Product information

BMW brake pads

8DB 355 012-321 / 8DB 355 015-601

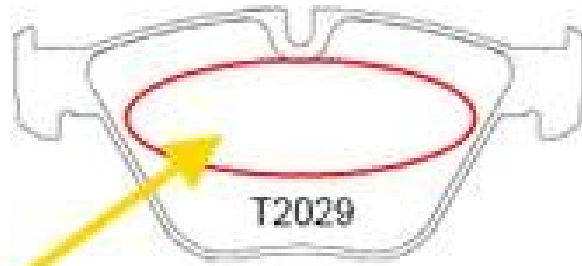
Due to a change in the serial equipment carried out by the vehicle manufacturer BMW, the following article allocation has been adapted as described in the following.

Brake pad 8DB 355 012-321 / T1596 will be replaced by brake pad 8DB 355 015-601 / T2029.

The difference between both brake pads is the missing retaining spring (A) on the brake pad 8DB 355 015-601 / T2029 on the first side. The missing retaining spring does not have any influence on the comfort conduct of the brake pad.
